Detroit River International Crossing Study

Air Quality Impact Assessment Supplementary Documentation

This report was prepared to address the comments of the Ontario Ministry of Environment (MOE) on the air quality assessment performed in support of the Detroit River International Crossing (DRIC) Environmental Assessment (EA) study (MOE Memorandum dated 19 February 2009). As the EA was undertaken over several years, it was considered important to provide an overview of how the air quality assessment developed over time. Also, given the broad interest in the findings of the air quality study, it is also considered important to provide additional context to the information presented in the Practical Alternatives Evaluation Working Paper: Air Quality Impact Assessment (May 2008) and the Air Quality Assessment: Technically and Environmentally Preferred Alternative, December 2008 (TEPA report). Overall, the current document may be viewed as a “bridging” document, intended to respond to the MOE’s questions and provide additional context to these two reports.

Table 1.1 MOE Comment Disposition Table

Figure 3.1 Receptor Grid and Modelling Domain

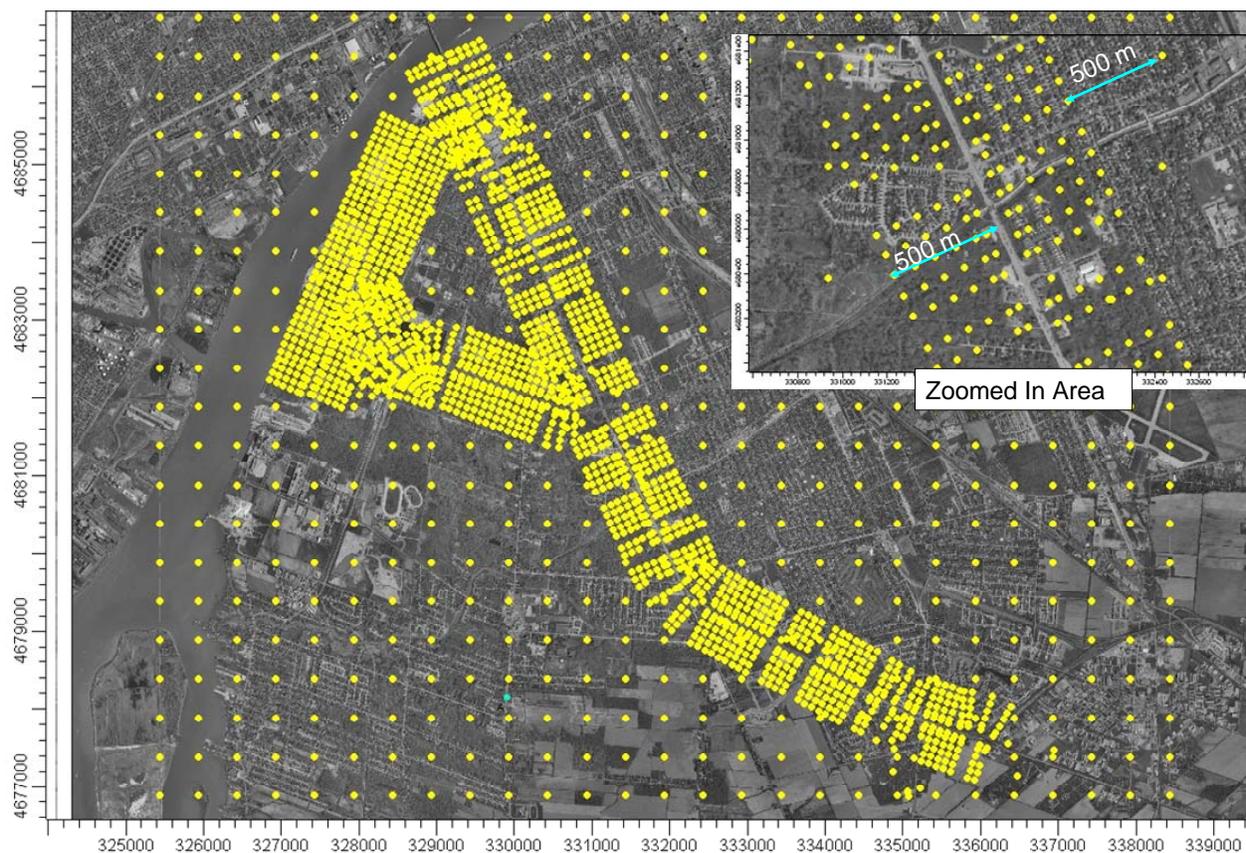
General Topic	MOE Comment	Comment
Graphical illustrations	Maps showing the modelled area and selected locations. Provide discussion on choice of locations	Figures 3.2 and 3.3 and Table 3.3 of the TEPA report show receptor locations and Tables in Appendix D of TEPA report should be examined in conjunction with these figures and Tables.
	Maps indicating concentrations at regularly spaced points.	Provided under separate cover
Green Space	Include modelling results for publicly accessible areas on the right of way.	Section 4.5.2 of the TEPA report included a limited discussion of impacts at tunnel portals. Section 5 this document expands the discussion.
Model Use	Provide discussion on results farther from the road, inputs should be included	Section 3.2 of this document discusses model performance at further distances
	More information should be provided on model inputs	Chapter 3 of the TEPA report provided discussion on the model inputs and Appendix C of the TEPA report provided sample calculations. Section 4 of this document provides detailed discussion of the appropriate use of background and the conservatism of silt loading in the TEPA assessment, Appendix A discusses silt loading in the Practical Alternatives report and Appendix B provides additional sample calculations

Figure 3.1 below was presented in the TEPA report as Figure 3.2 and is repeated here to illustrate the receptor grid and modelling domain.
